# Z07 SYSTEM BLOCK DIAGRAM

PROJECT : Z07  
Quanta Computer Inc.

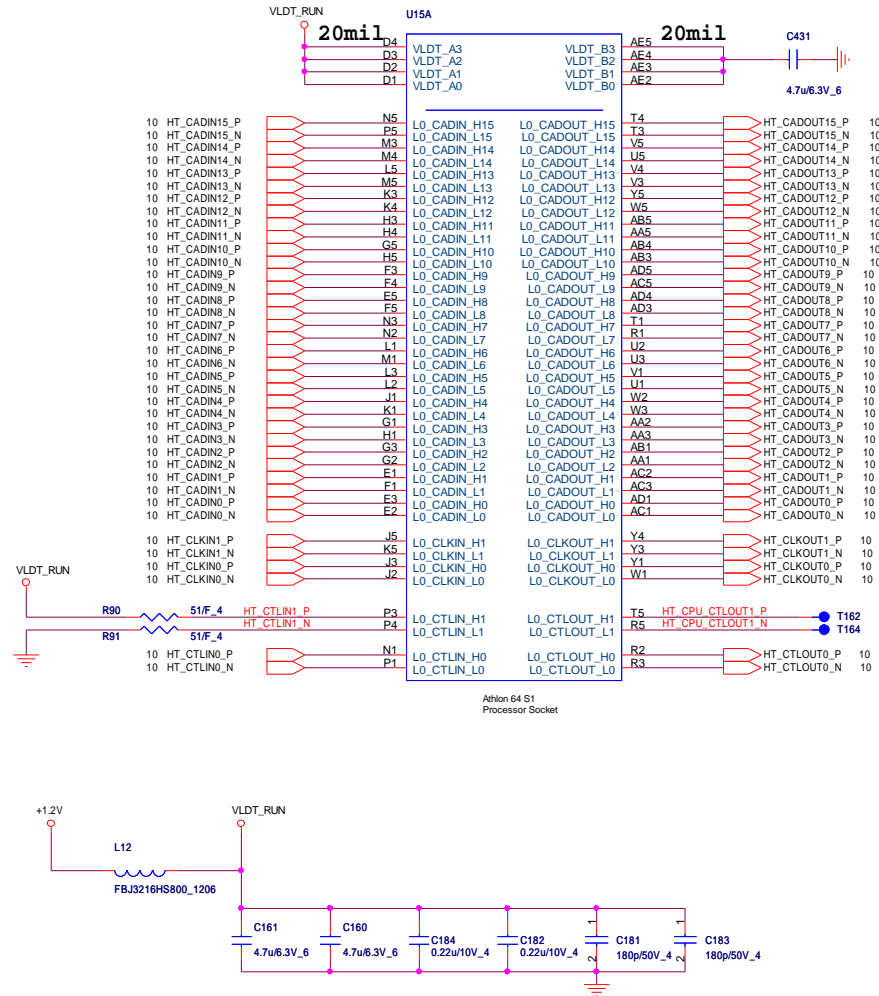
Add 10p for IMI issue (Suggestion by Silego)

Board ID	ID3	ID1	ID0
			H L
			H L
	L	L	L

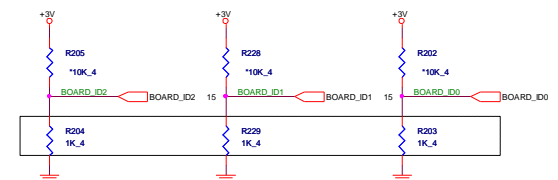
&lt;---- Before

(1)Because GPIO pin of South Bridge have internal PU or PD.It will let Board ID become floating(+1.5V) when external circuit PD  
(2)Change external Pull down to 1K ohm for all BOARD\_ID

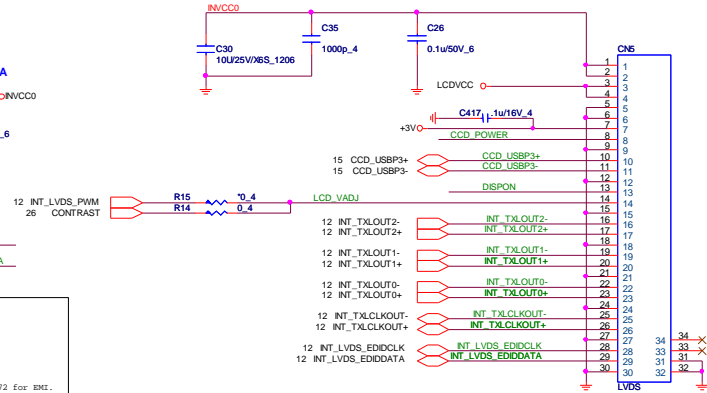
Rev:B Add C573,C572 Err BM1.

## RJ45 connector

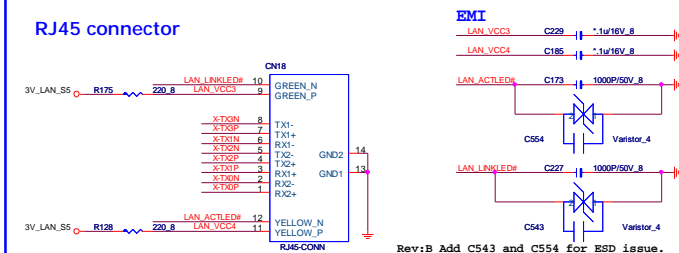
Rev:B Add C543 and C554 for ESD issue.

## MMB

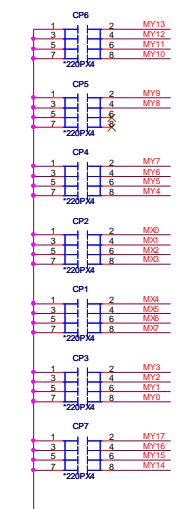
## Rev:C Add Q27,Q37,R93,R118 for MMB leakage
